**Curtis H. Stanton Energy Center
Combined Cycle Unit A**

Sufficiency Report

Re: Stanton Unit A Combined Cycle Project
Supplemental Site Certification Application
FDEP File No. PA 81-14SA2
DOAH Case No. 01-0416EPP
OGC Case No. 01-0176
Response to Statement of Sufficiency

ORLANDO UTILITIES COMMISSION
 ORLANDO, FLORIDA
STANTON ENERGY CENTER COMBINED CYCLE PROJECT
T-LINE SILT FENCE PLAN

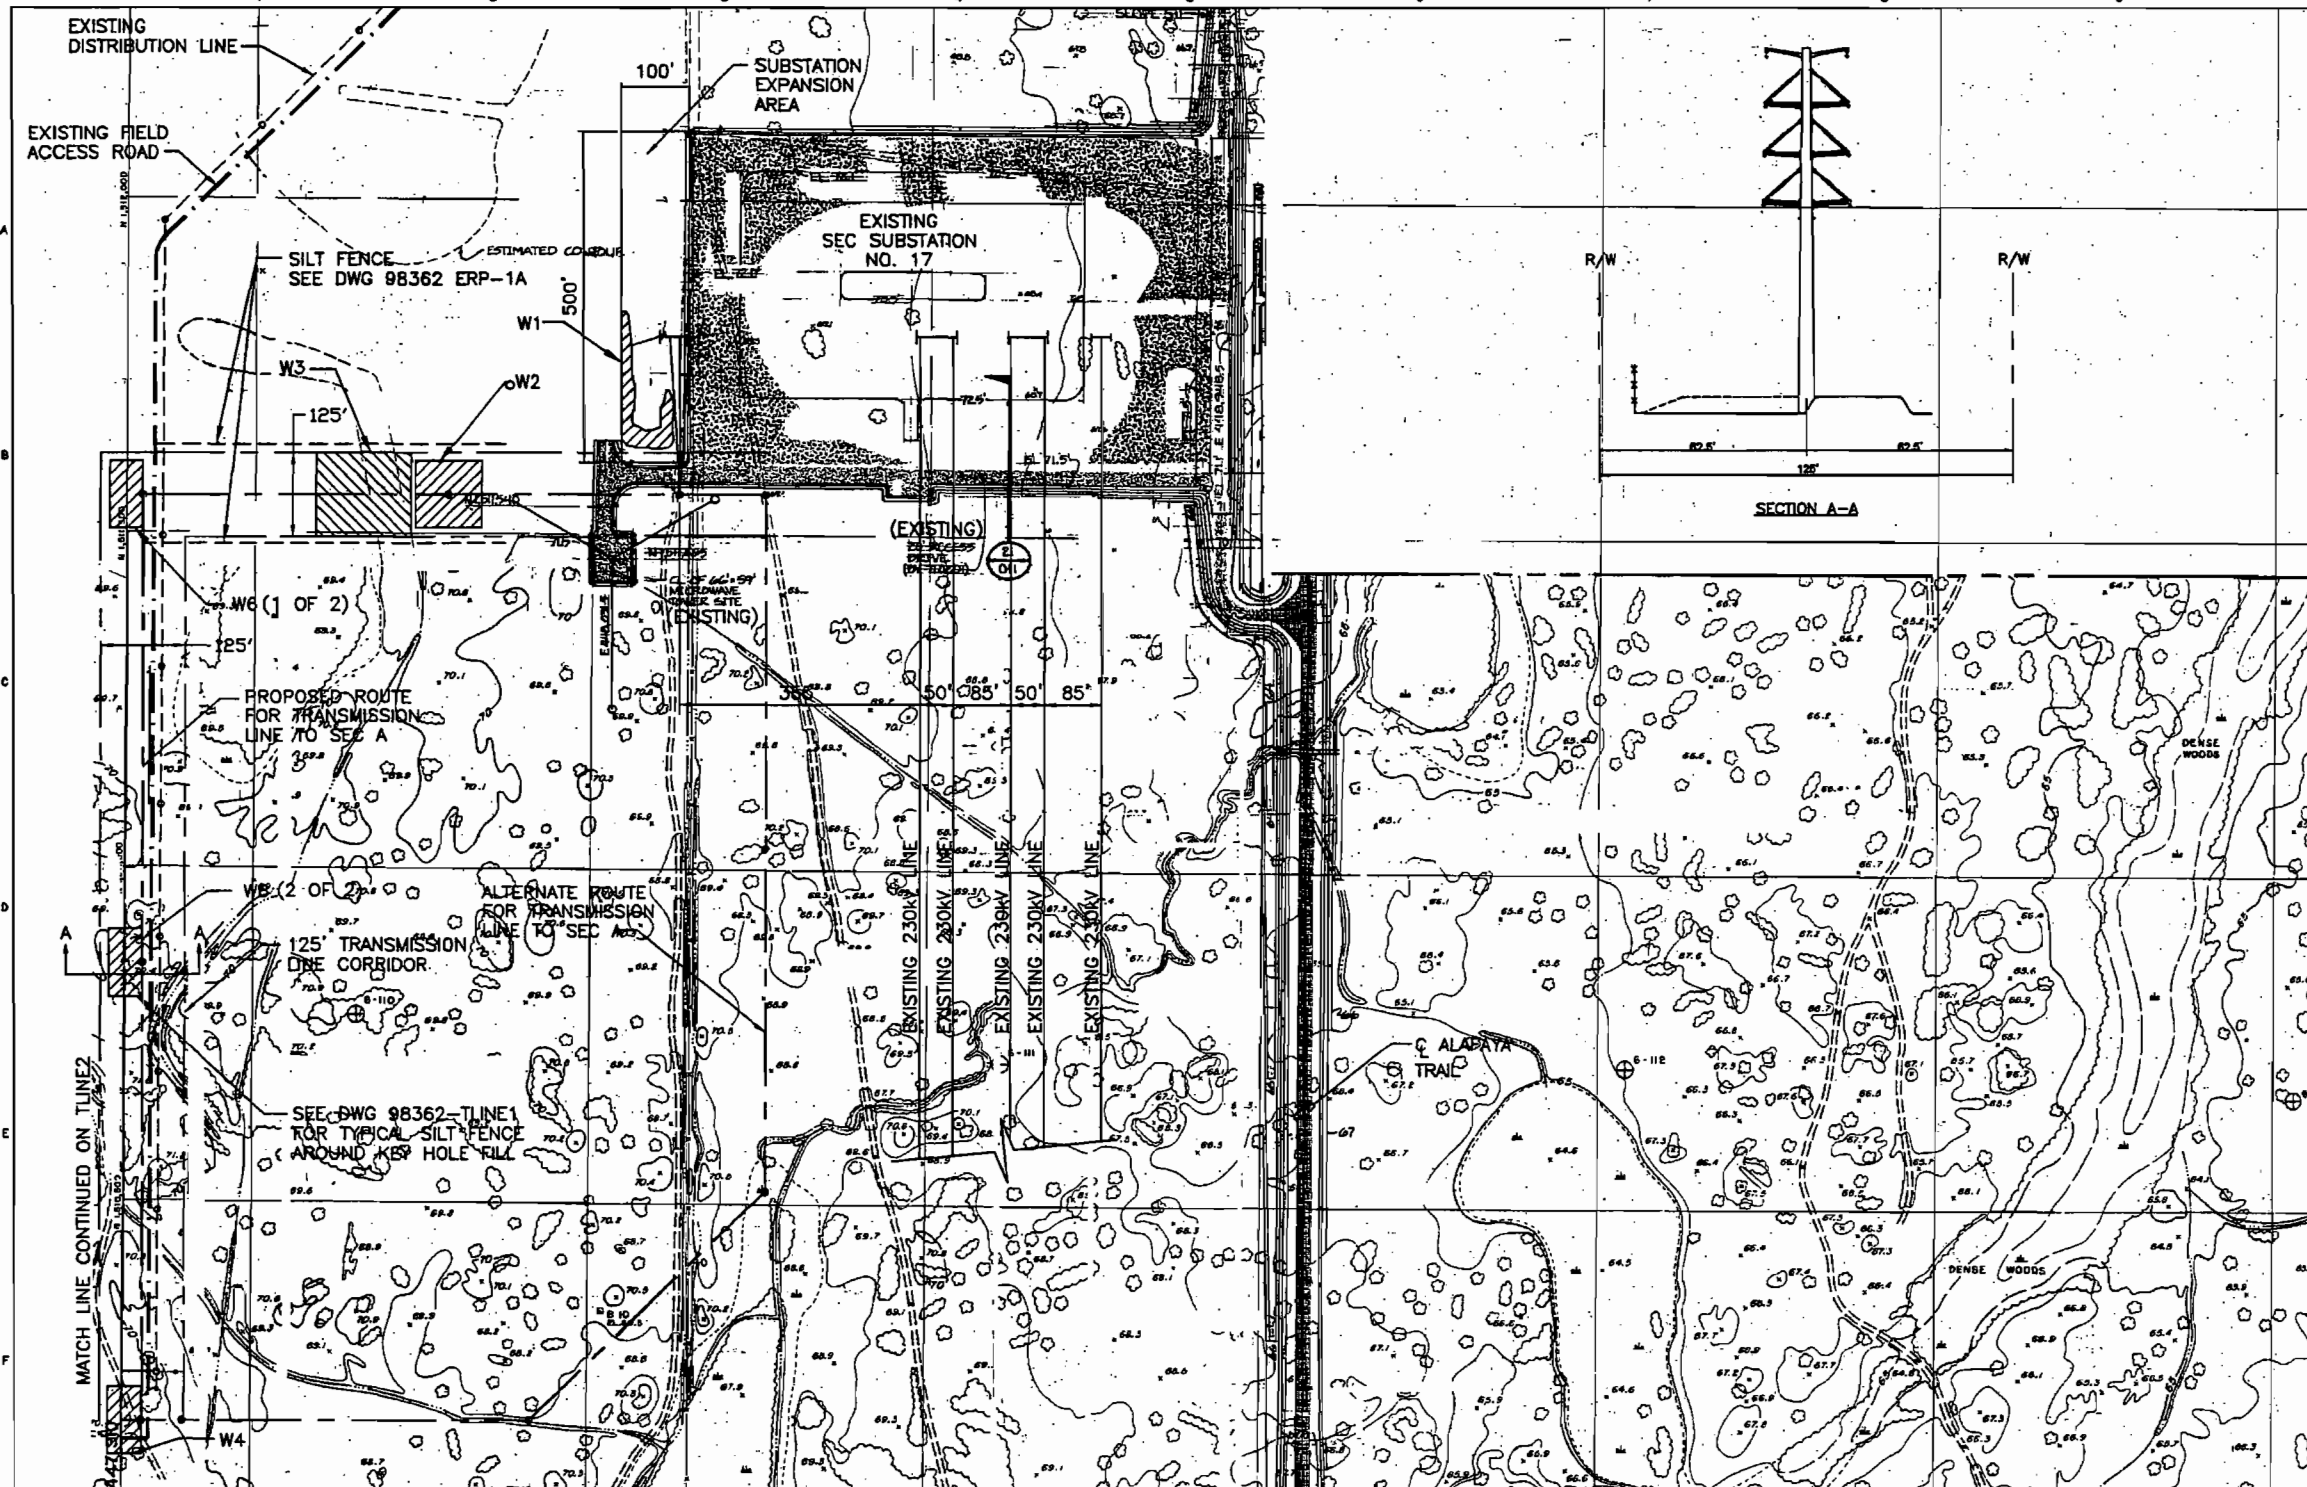
6. *Drawing Figure 6.1-1 is not legible.*

Response: Large scale drawings of the proposed and alternate transmission line routes are attached as Figure 6.1-1. The drawings have been signed and sealed.

- a) There are no named roads in the near vicinity of the transmission line, which is entirely on SEC property. The closest road is Alafaya Trail. This road is now marked on Drawing TLINE3, Figure 6.1-1, revised on March 21, 2001.

- b) The existing transmission lines going south out of the SEC Substation are now shown on Drawing TLINE 3, Figure 6.1-1.
- c) The location of the transmission centerline is shown on Figure 6.1-1.

- d) Revised Drawing TLINE3, Figure 6.1-1 illustrates the location of the wetlands, ditches, surface waters in numerical order (W-1 through W-6).
- e) Revised Drawing TLINE3, Figure 6.1-1 illustrates the size and width of the transmission line impacts.

Location Map
Figure 6.2-1

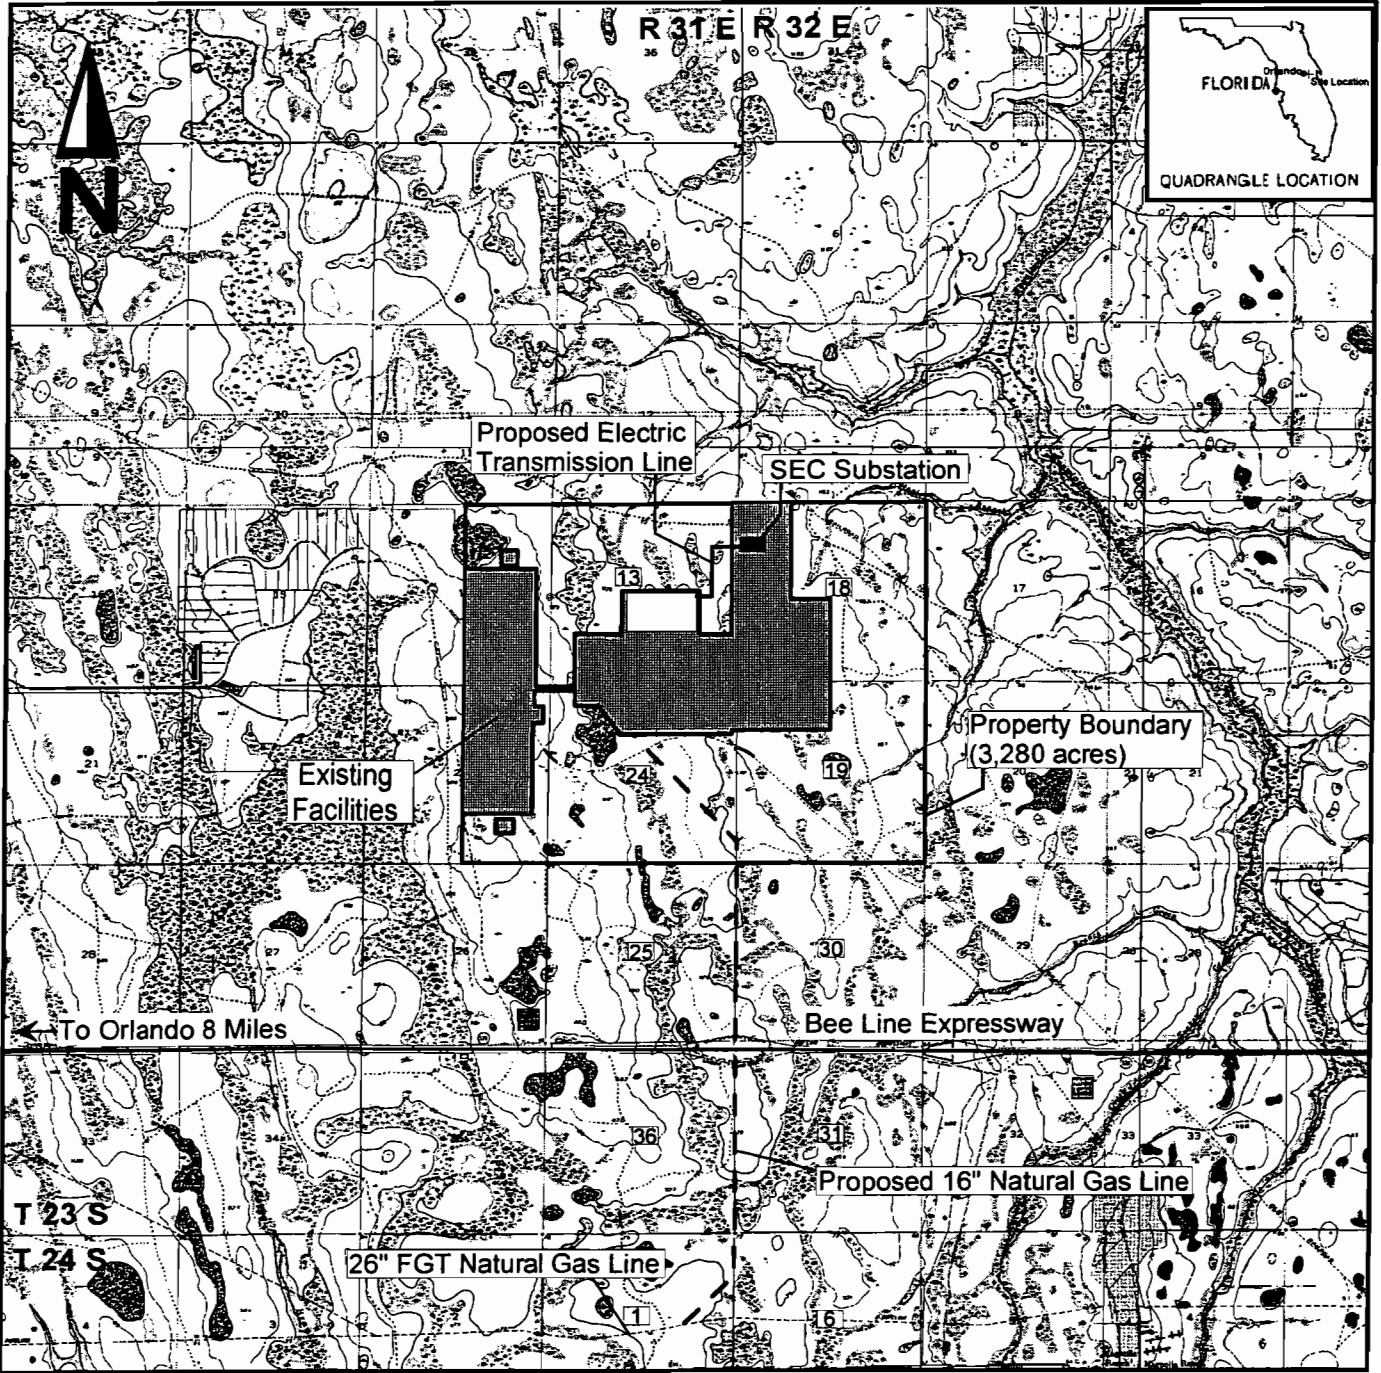
- a. *Demonstrate why a 16-inch pipeline requires a 50 feet wide permanent corridor.*
- b. *Drawing Figure 6.2-1 may serve as an overall location map for the proposed natural gas pipeline provided road names and section, townships and ranges were added to the drawing and the drawing is legible.*
- c. *Detailed plan and cross section drawing are required for the entire pipeline. Include in the plan view drawing:*
 - a) *wetland locations*
 - b) *wetland types*

- b. Revised Figure 6.2-1 is included herein and provides the requested legal description for the location of the project and the natural gas pipeline. Refer to Drawing 098362-DS-S3300 for road names and locations.

TYPICAL GAS LINE TRENCH EXCAVATION
FIGURE 6.2-2 (04-17-2001)

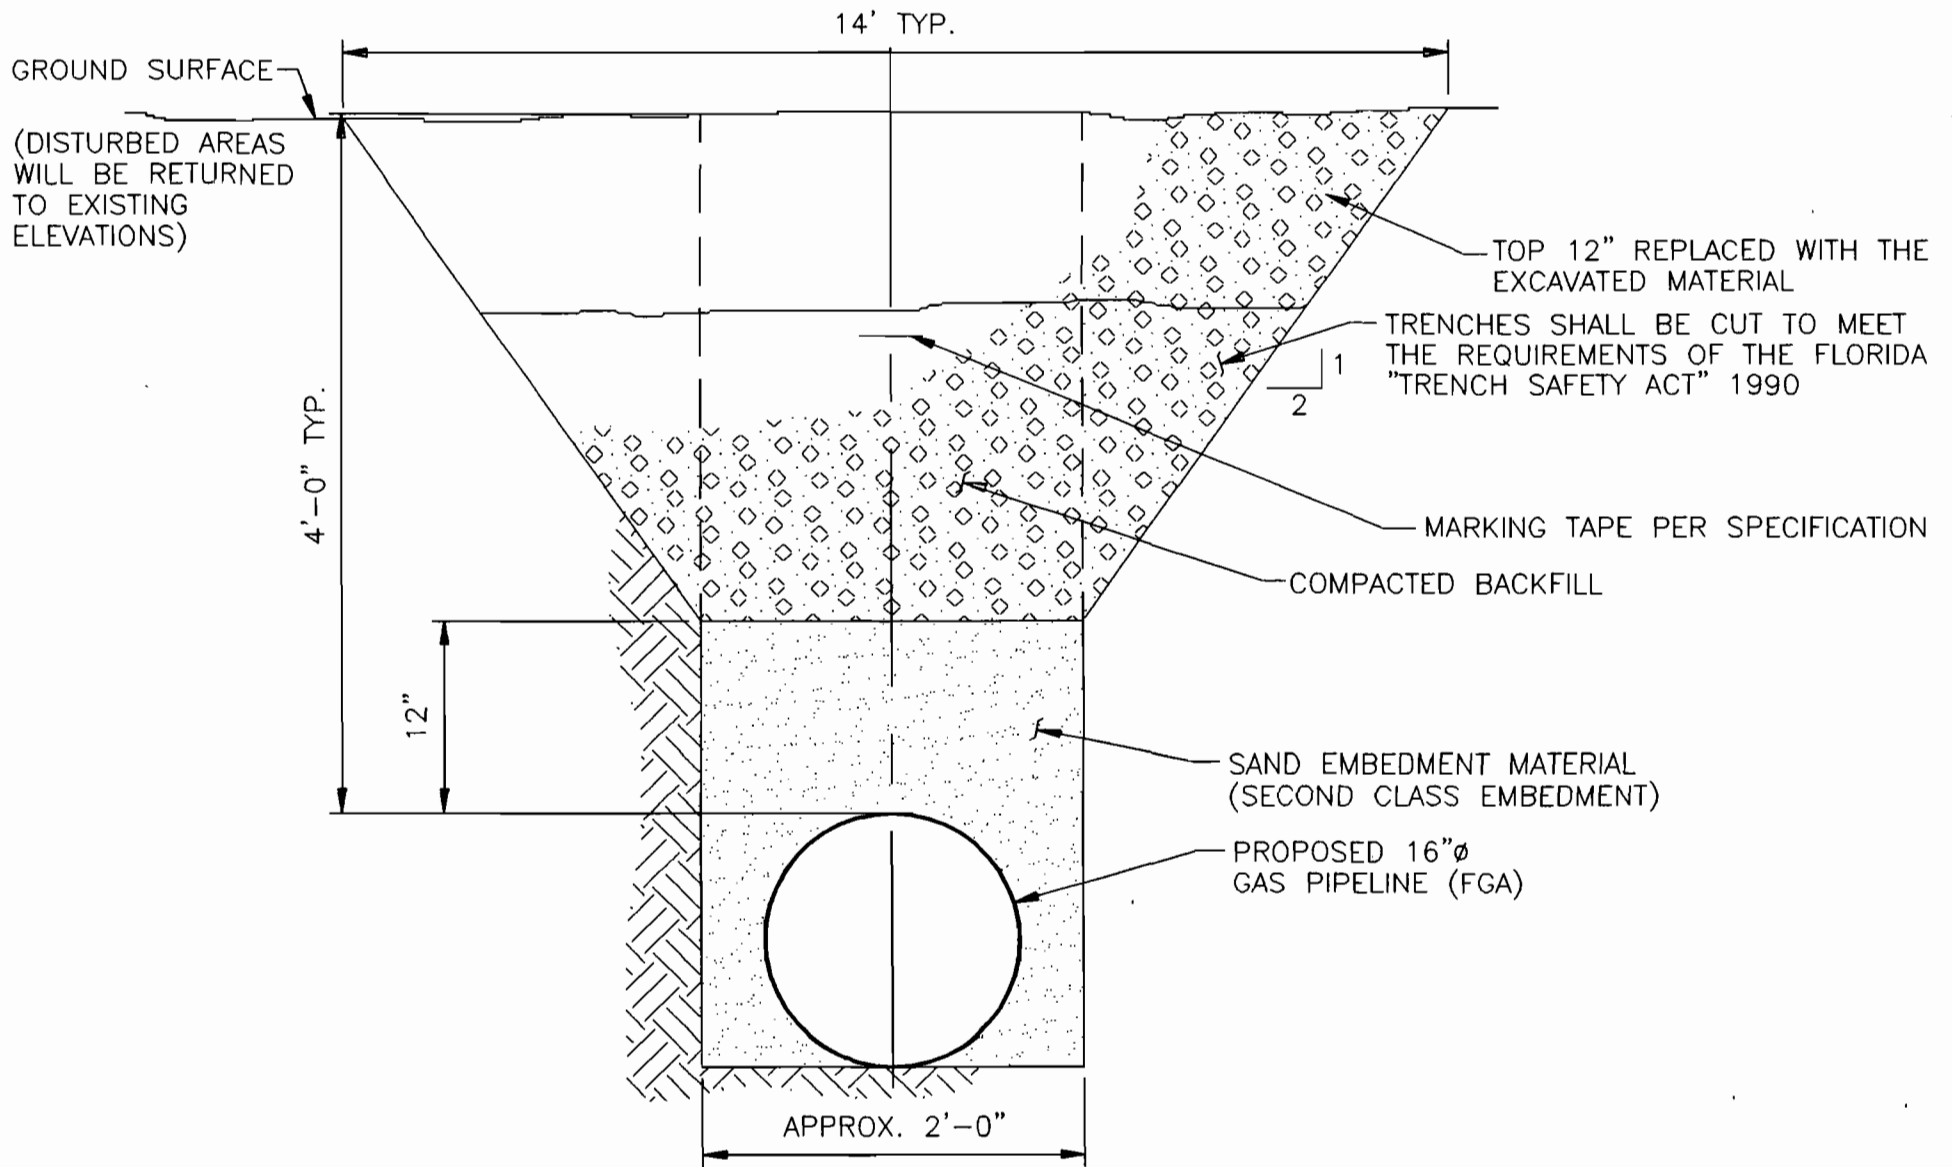
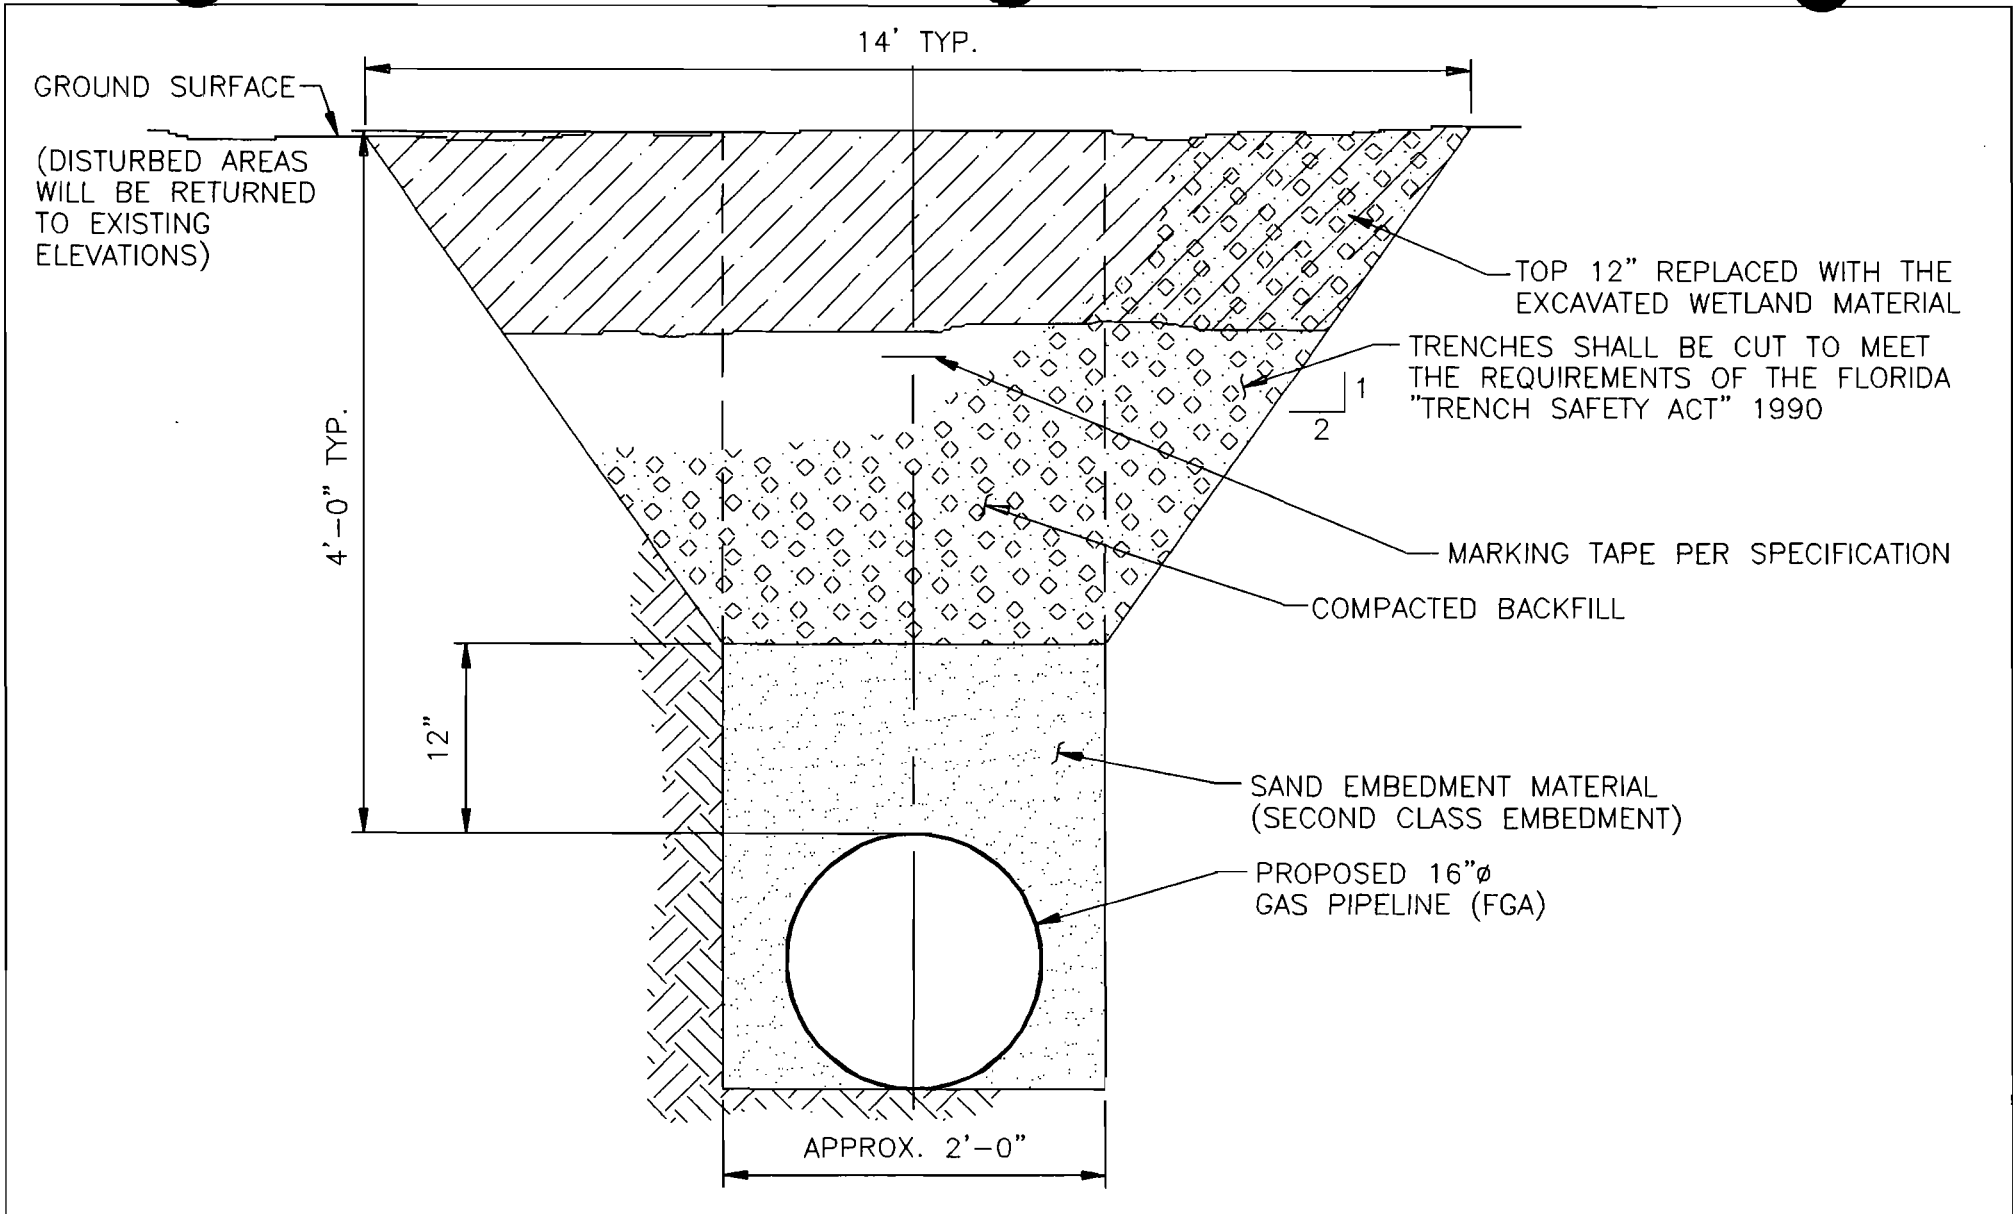
21. *Figure 6.2-2 please revise to include the following to this exhibit:*
- a. *total width in wetlands*
 - b. *statement that all disturbed area will be returned to pre-existing elevations.*

Response: See updated Figures 6.2-2 and 6.2-2A.
